Subject: EPA Comments on NRG - Huntley Generating Station, Tonawanda, NY  
Round 10 Draft Assessment Report

RE: Comment Request on Coal Ash Site Assessment Round 10 Draft Report –  
NRG Huntley Power, LLC's Huntley Electric Generating Station

Appendix A  
NRG Comments on  
Draft Report of Dam Safety Assessment of Coal  
Combustion Surface Impoundments  
NRG Energy  
Huntley Generating Station  
Tonawanda, NY

Re: GZA Letter Response to AMEC  
Dam Safety Assessment Report of  
Coal Combustion Surface Impoundments  
NRG Energy Huntley Generating Station  
Tonawanda, NY

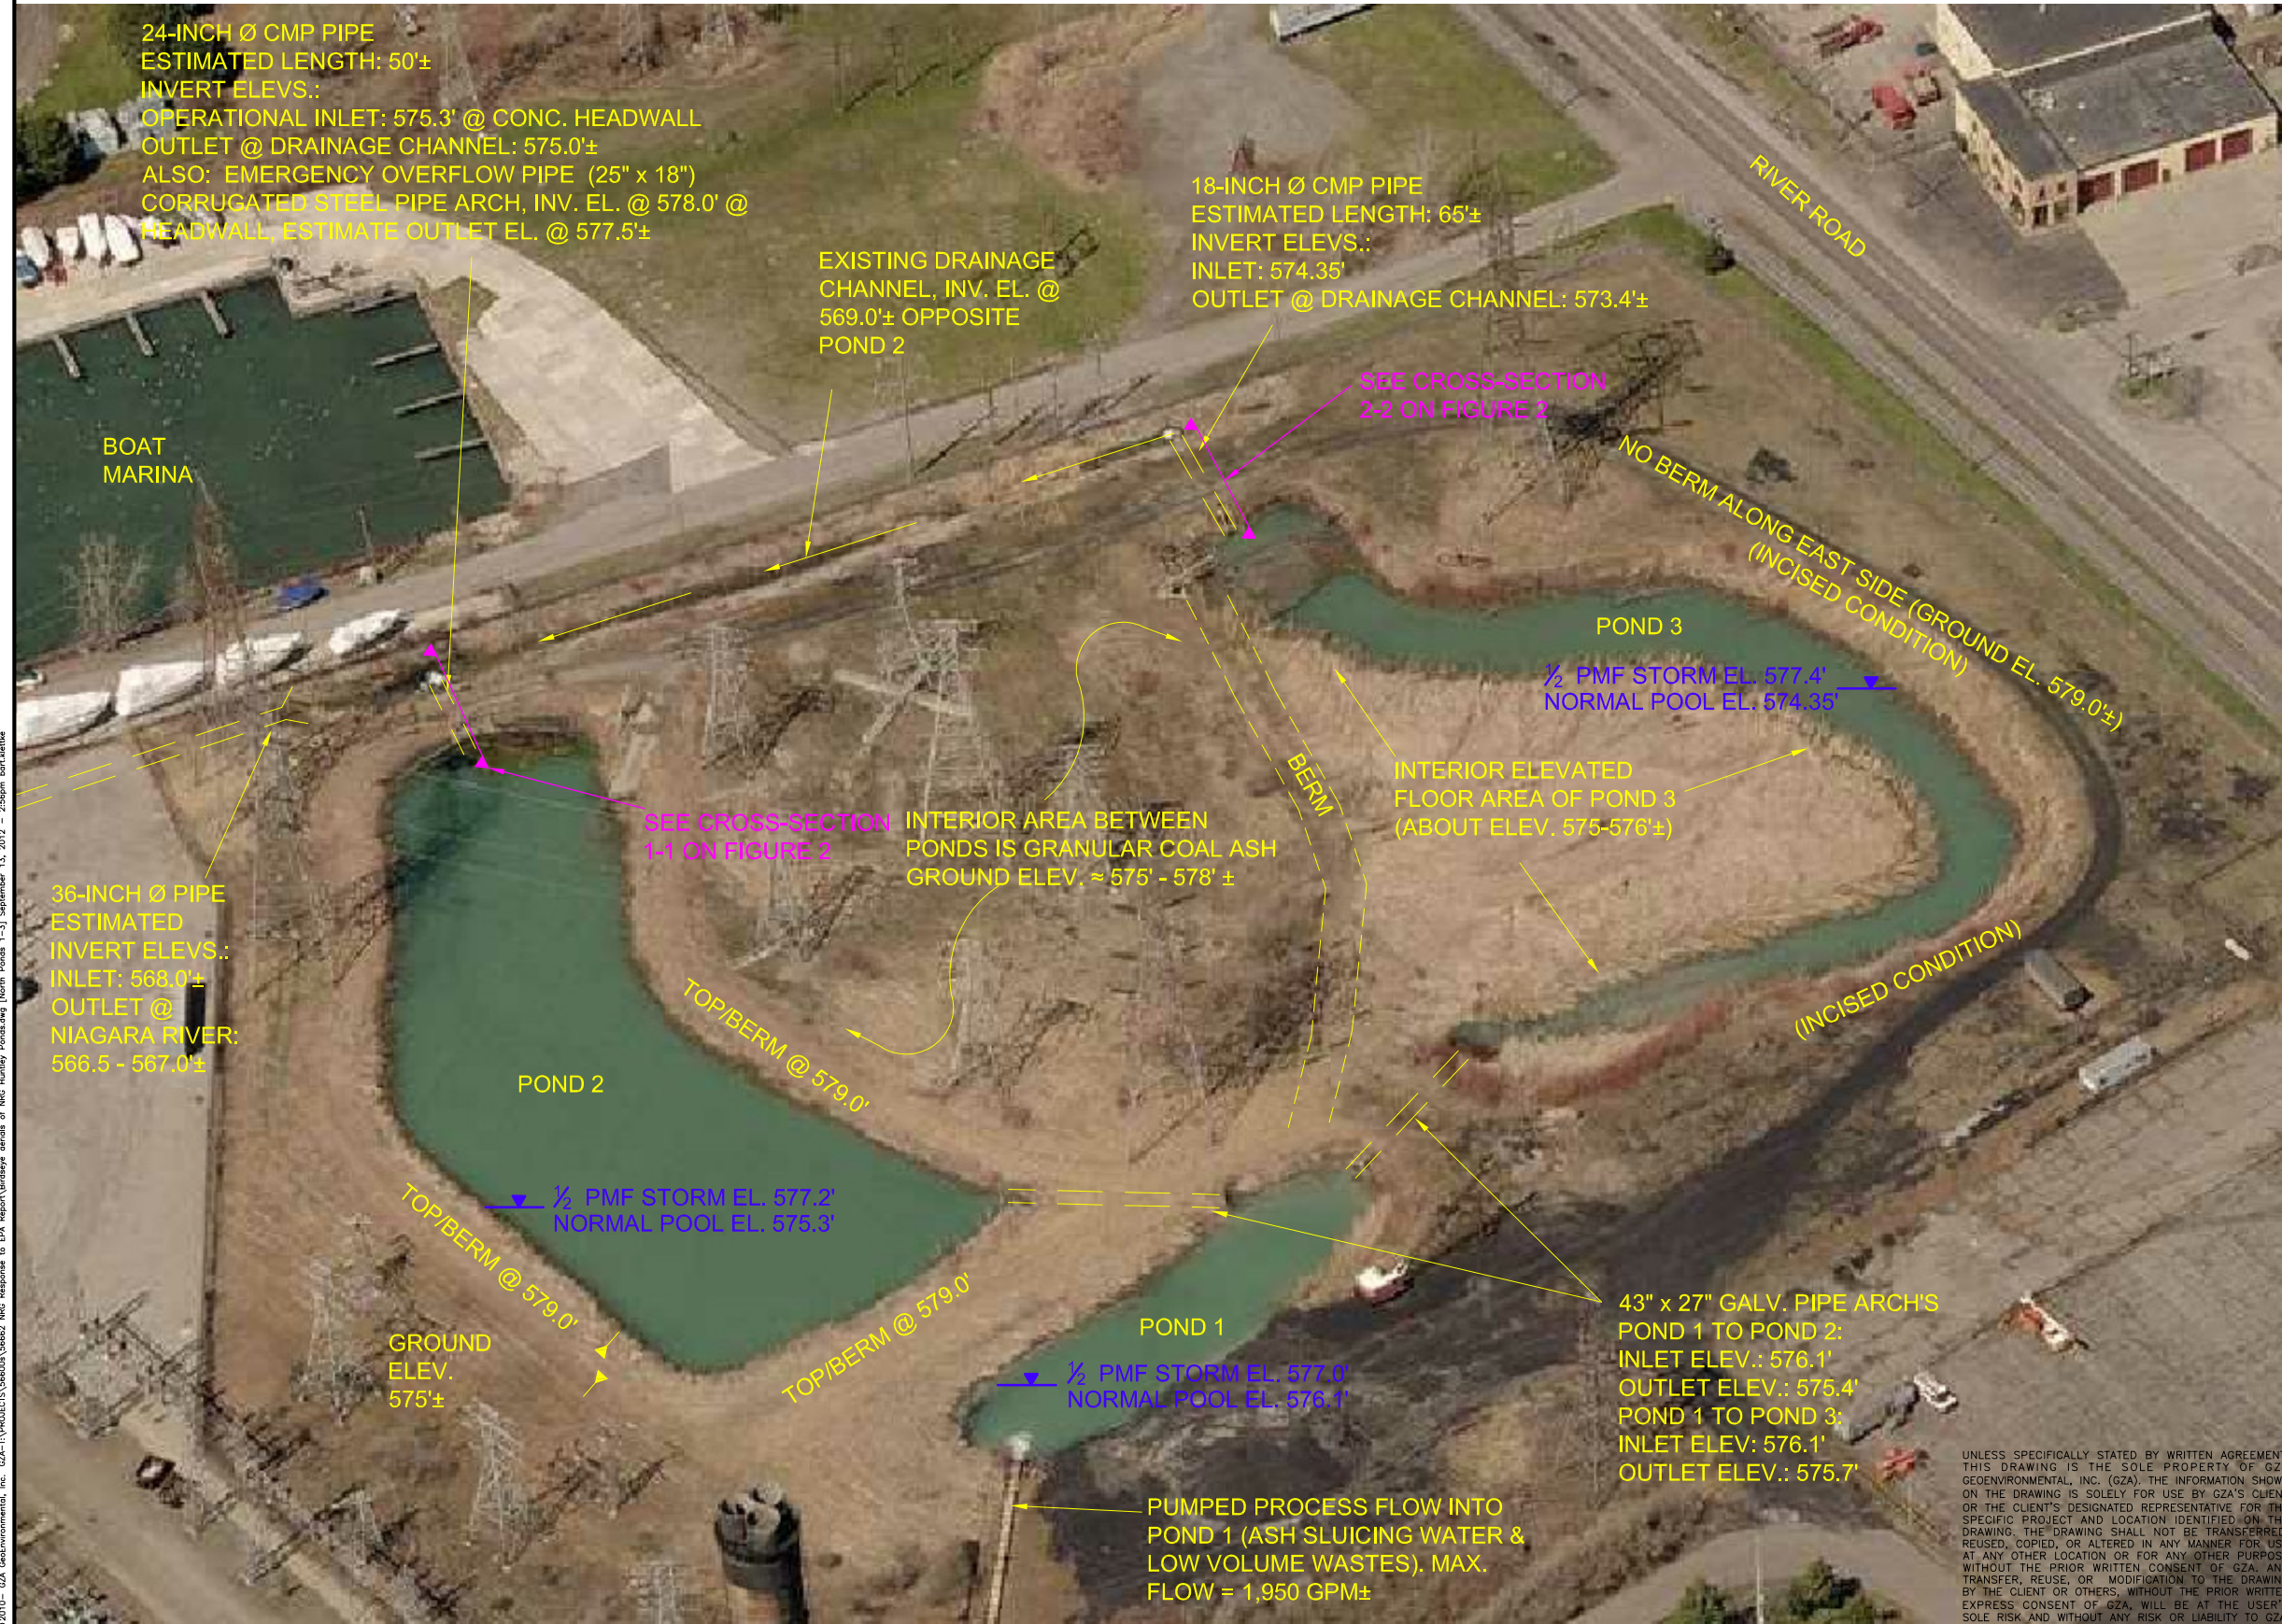
A plan view of the North Basins is presented on attached Figure 1. Basin and drainage pipe information is provided on the figure. Figure 2 shows cross-sections of the outlet drainage pipes from Ponds 2 and 3 draining into the adjacent drainage ditch.

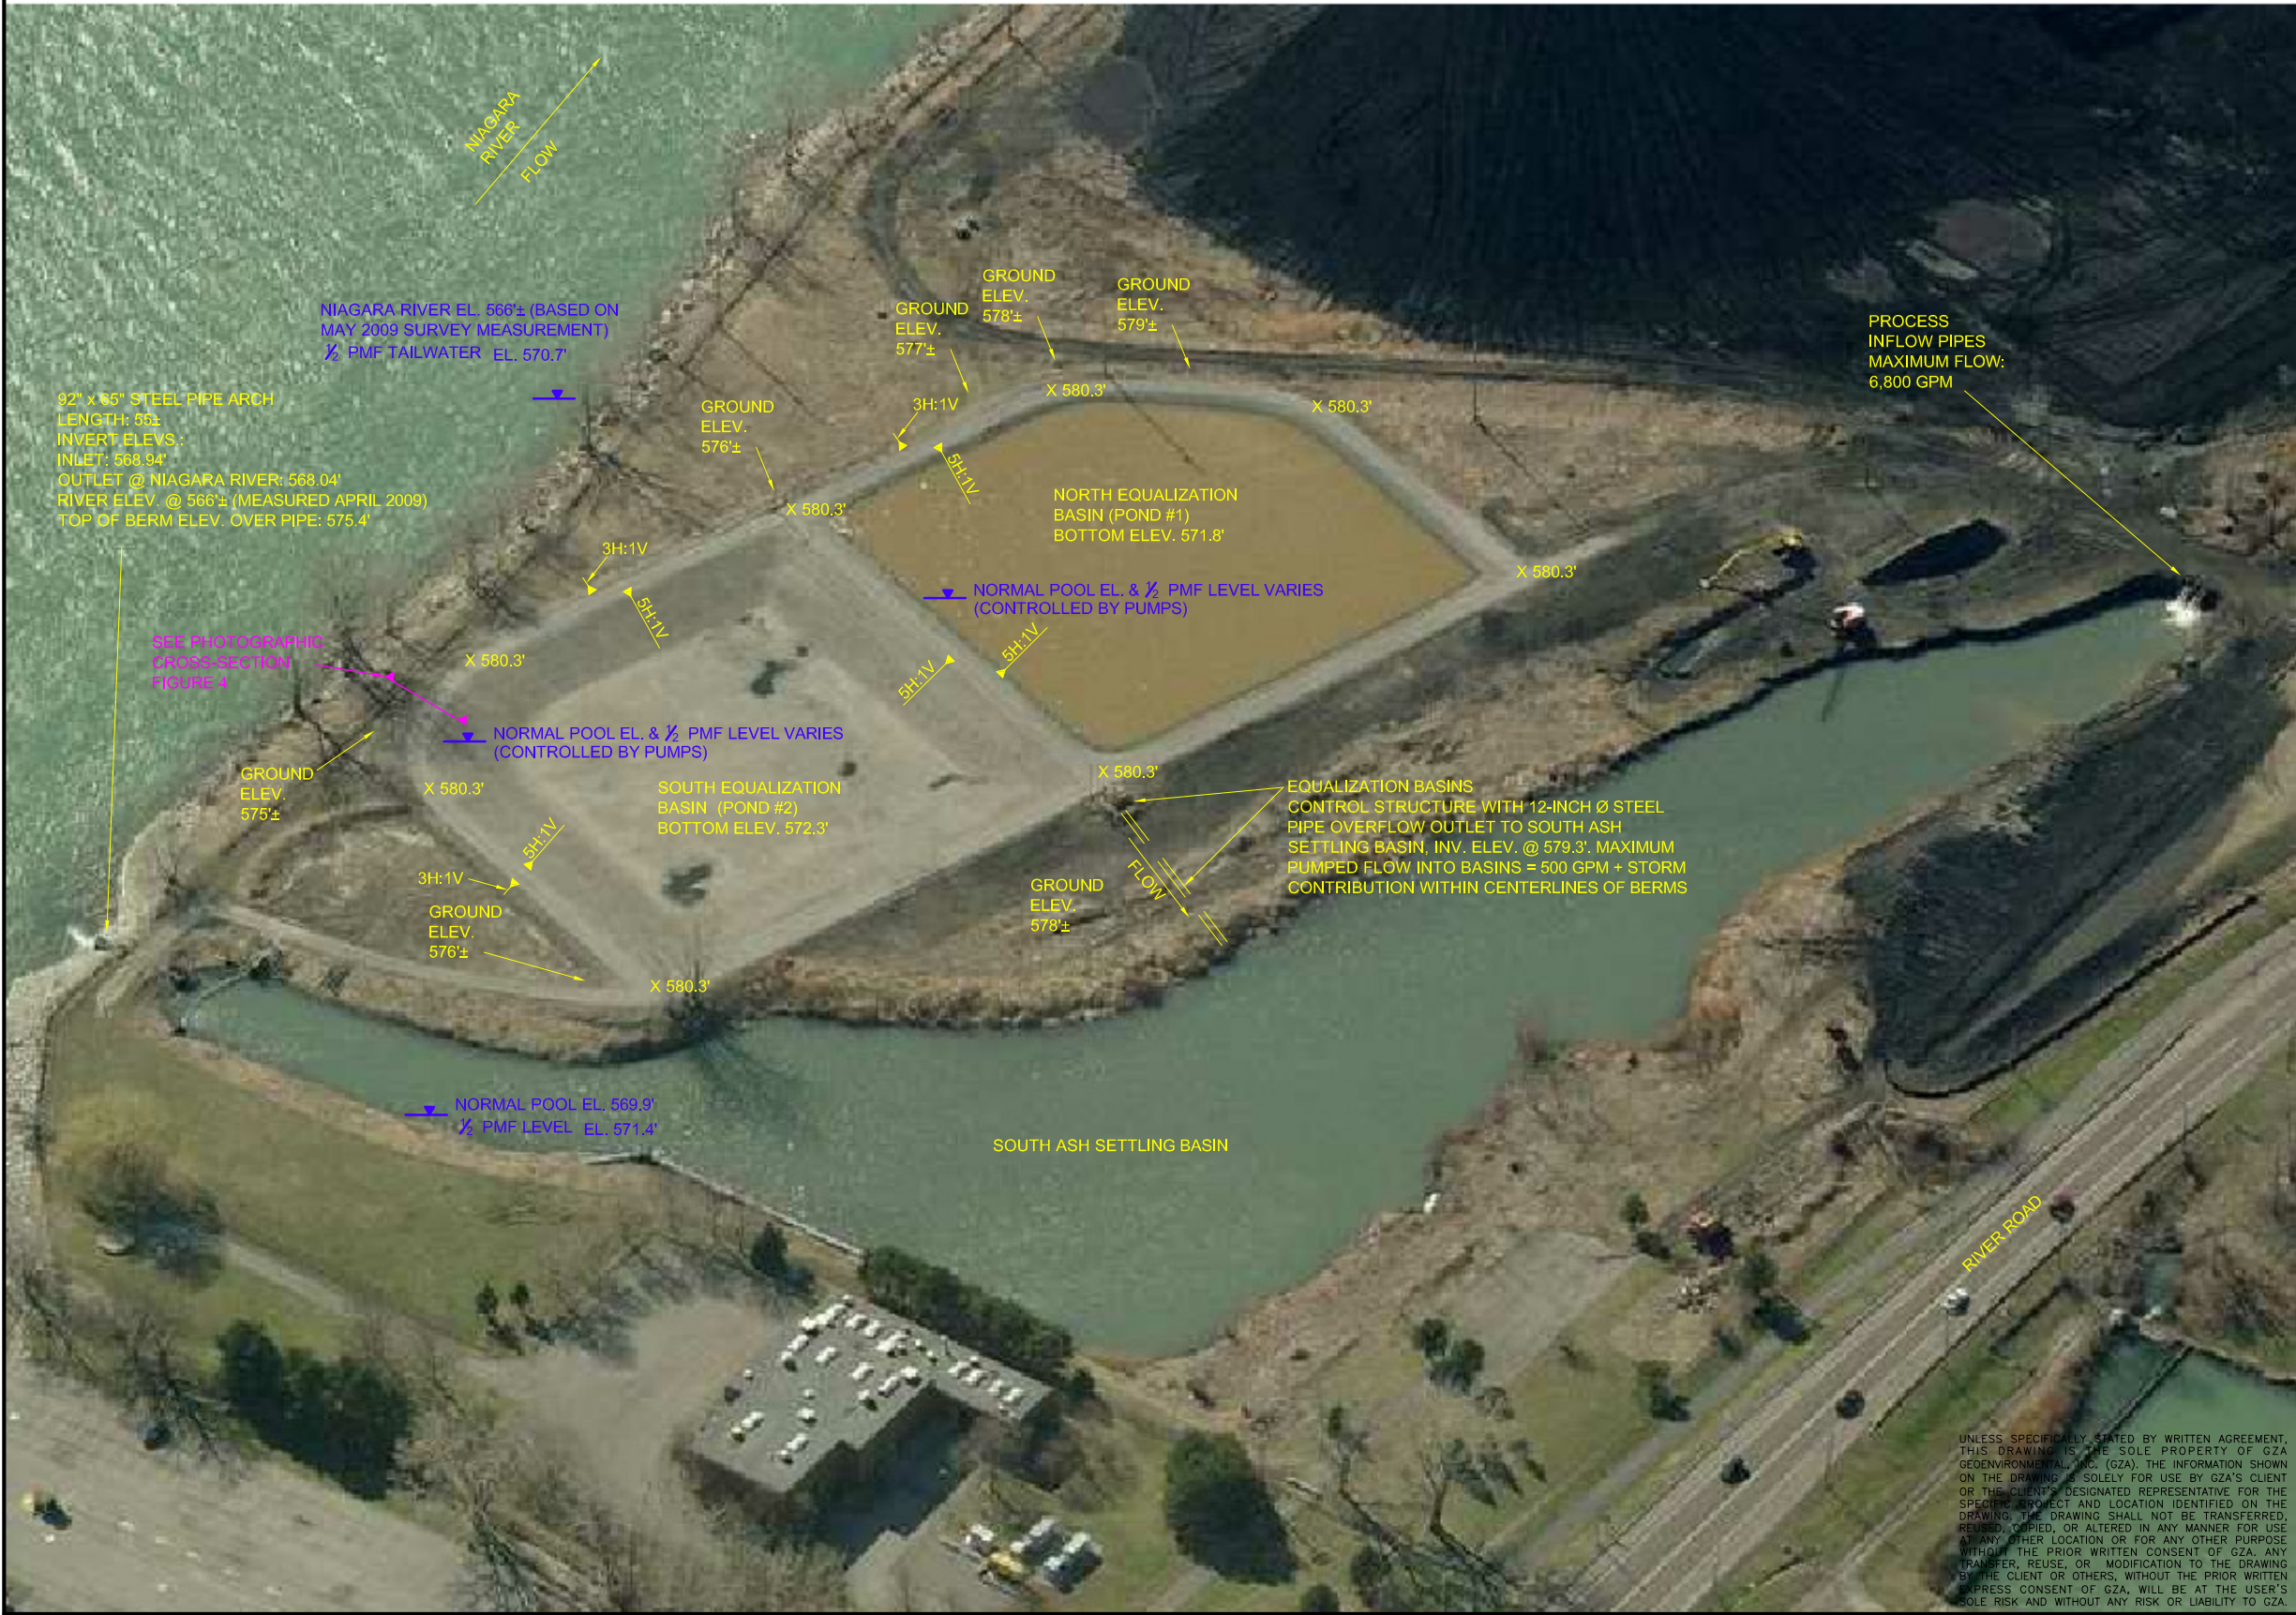
A plan view of the South Basins is presented on attached Figure 3. Basin and drainage pipe information is provided on the figure. Figure 4 presents a cross-sectional photograph of the southwest corner of the South Equalization Basin, showing dimensions for discussion purposes presented in our Conclusions section below.
